9/13/96	Class B Concrete changed to Class A.
6/14/96	Notes added to clarify plans.
DATE	REVISION
STATE OF HAWAII DEPARTMENT OF TRANSPORTATION HIGHWAYS DIVISION	
DRAINAGE PLAN	
KALANIANA'OLE HIGHWAY RESURFACING	
Kailua Rd. to Hilo St.	
Project No. 72A-01-96M	
Scale: 1"=40'	Date: May 1996
SHEET No. 44 OF 44 SHEETS

KALANIANA'OLE HIGHWAY RESURFACING

Project No. 72A-01-96M

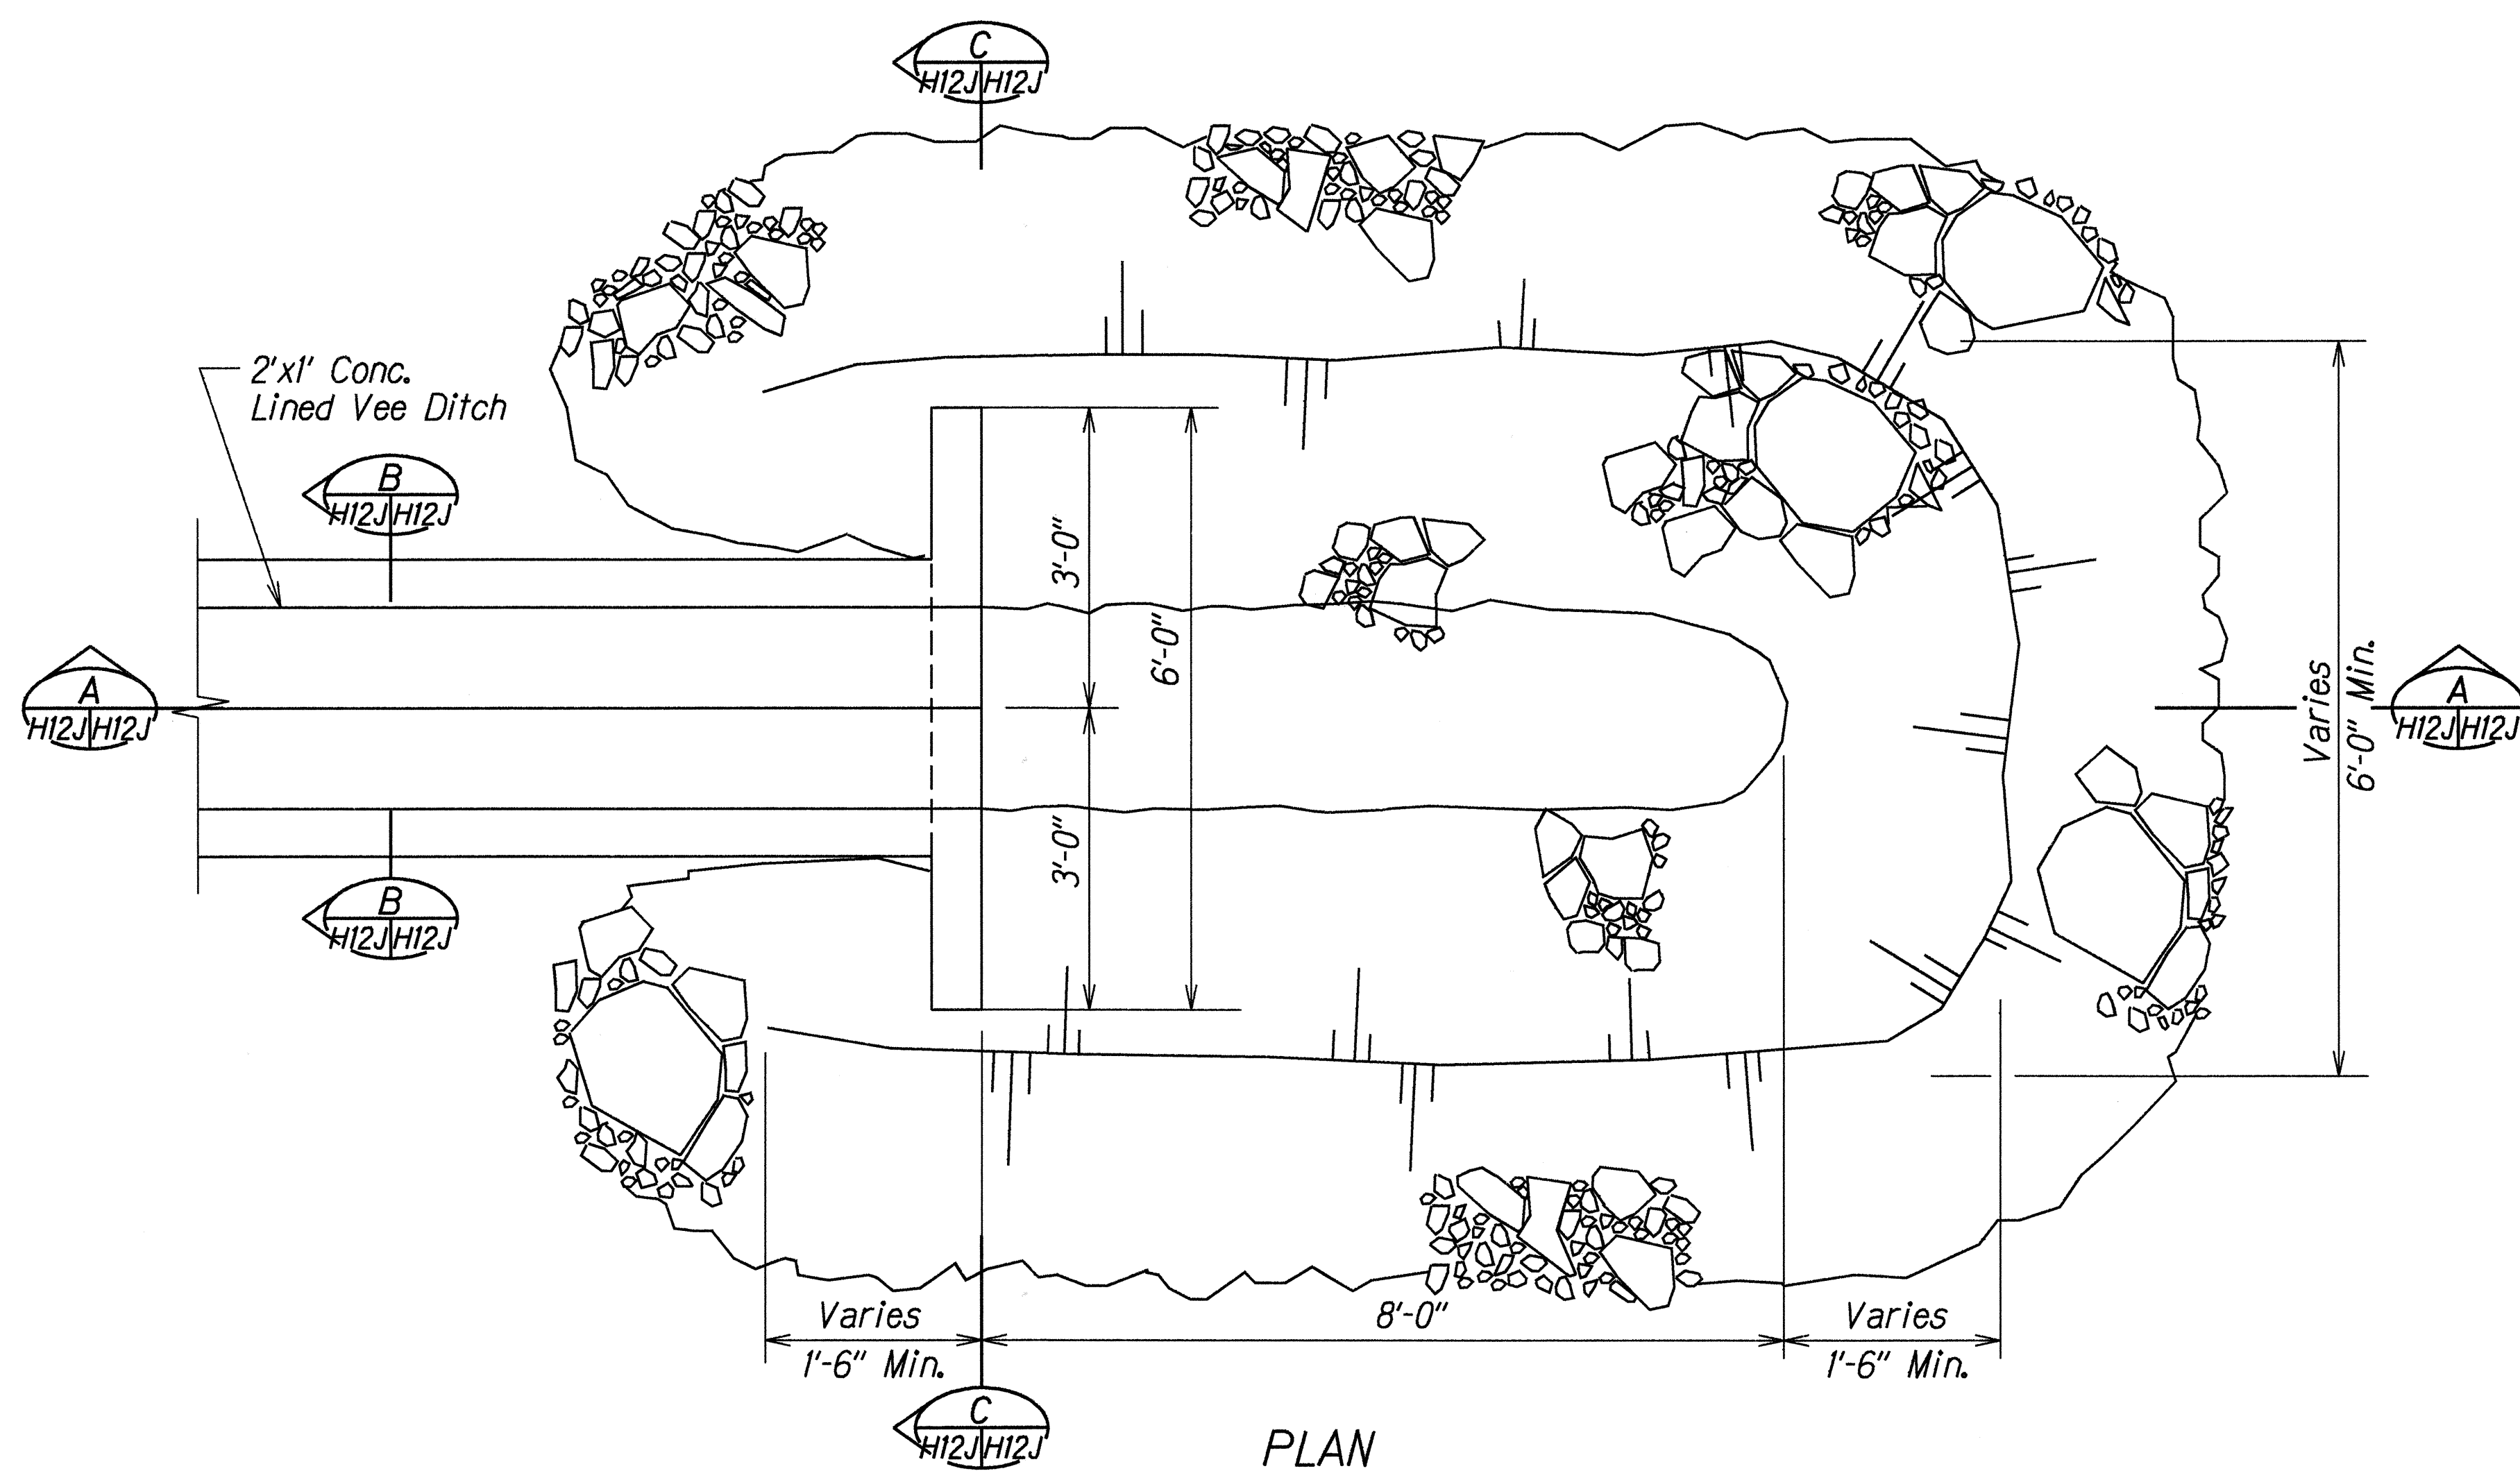
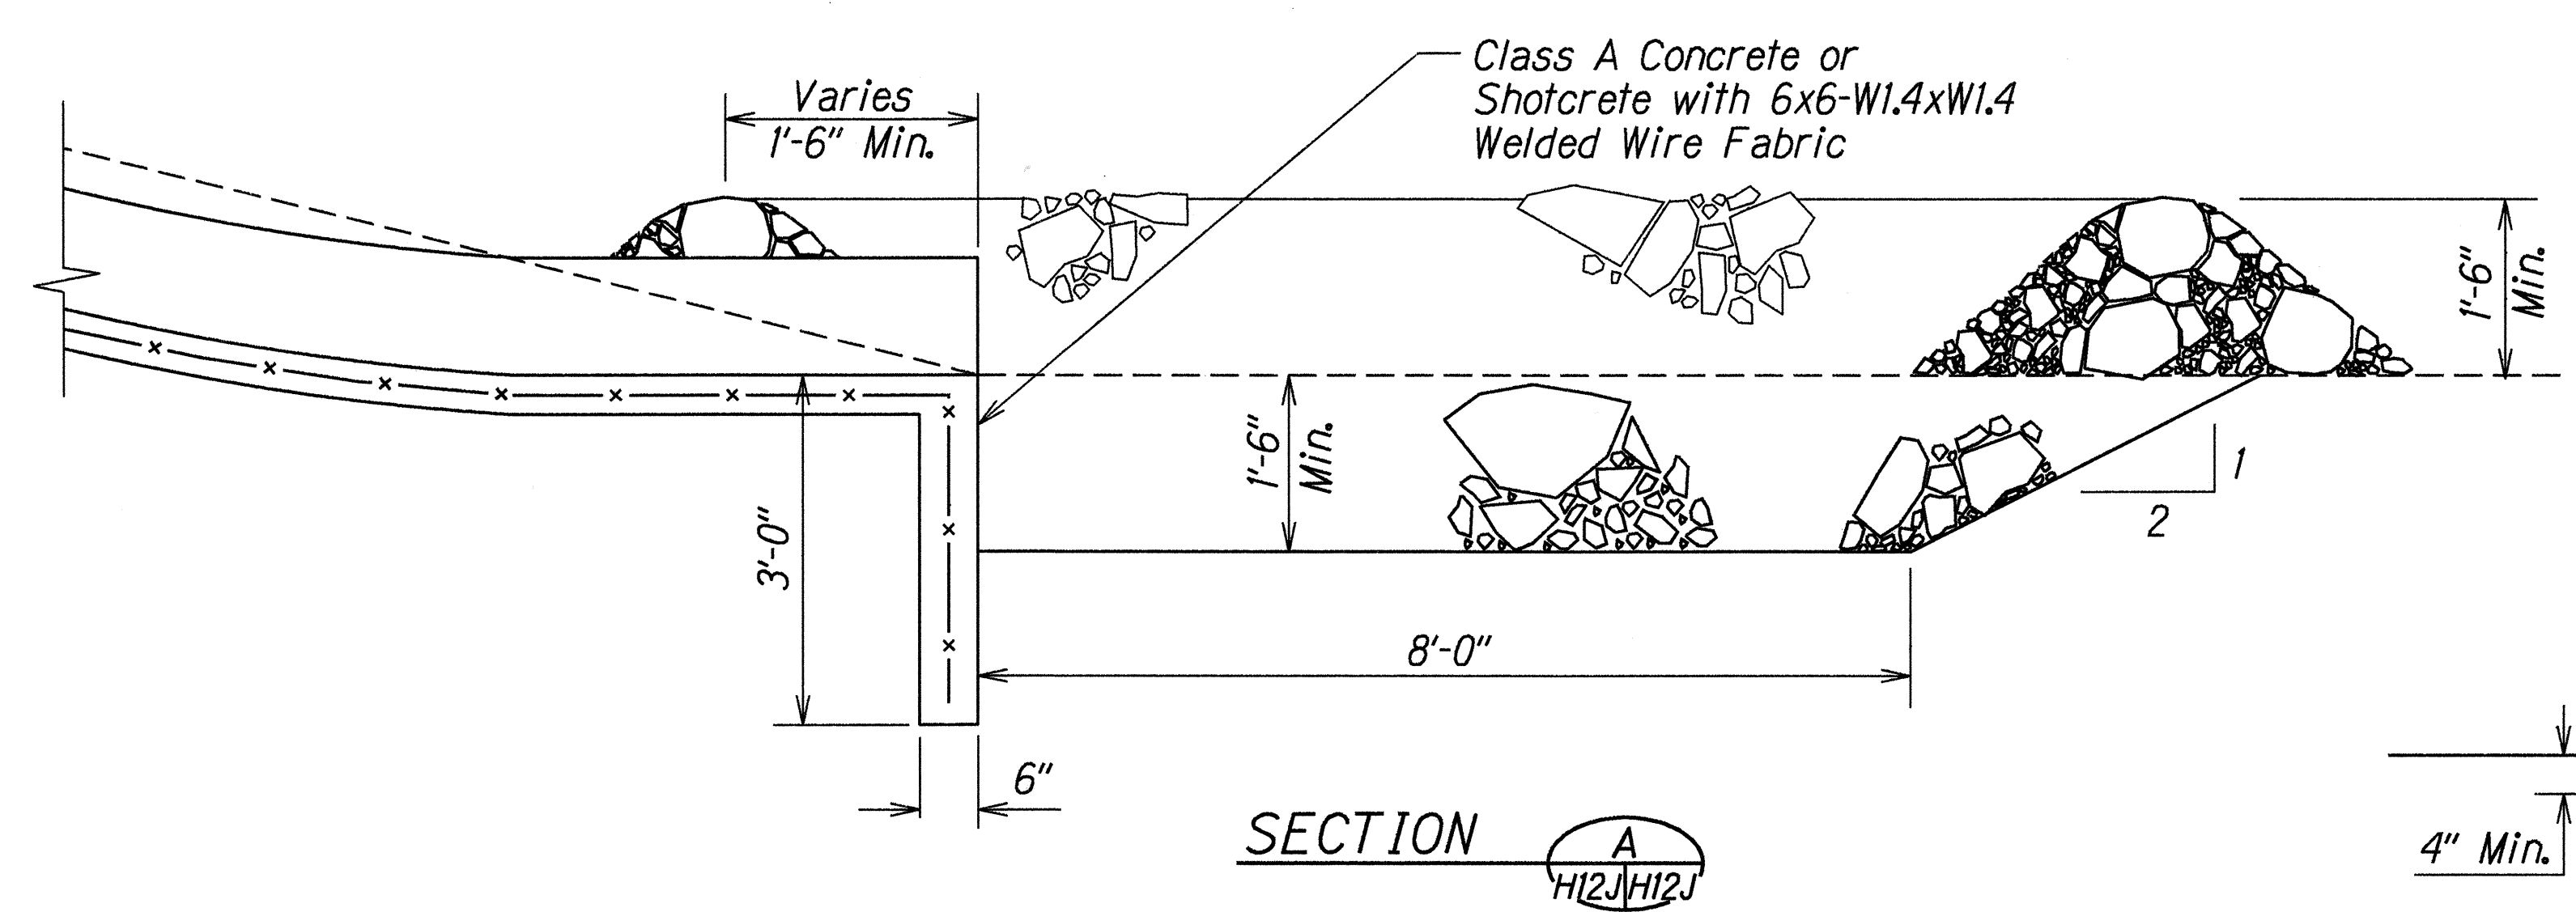
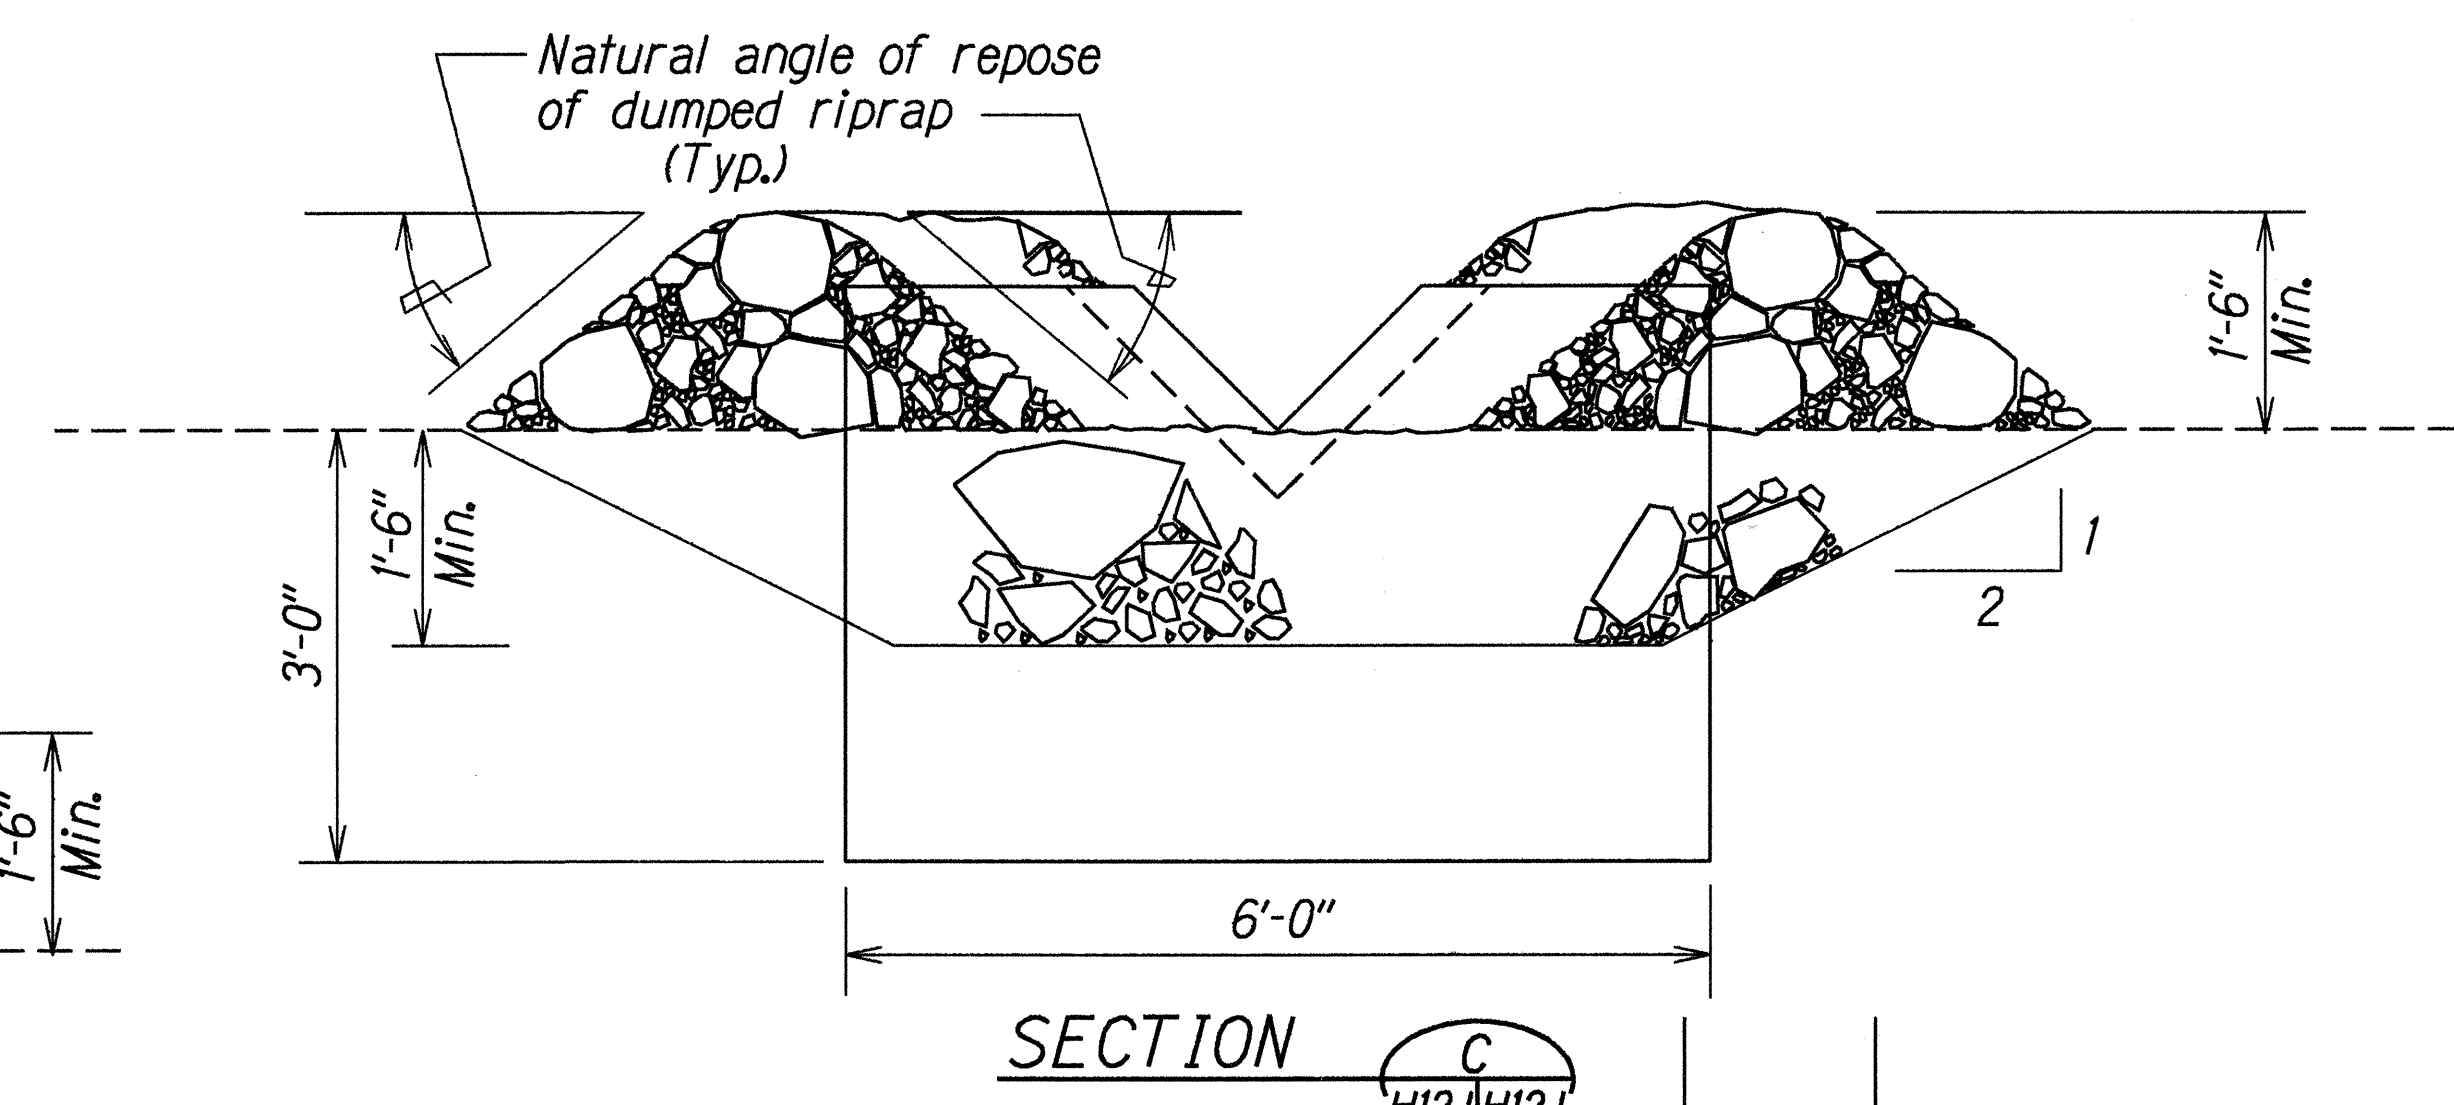
9/13/96	Class B Concrete changed to Class A.
6/14/96	Details added to complete drainage plan.
DATE	REVISION
STATE OF HAWAII DEPARTMENT OF TRANSPORTATION HIGHWAYS DIVISION	
DRAINAGE DETAILS	
KALANIANA'OLE HIGHWAY RESURFACING	
Kailua Rd. to Hilo St.	
Project No. 72A-01-96M	
Scale: 3/4"=1'-0"	Date: May 1996
SHEET No. H12J OF 12 SHEETS
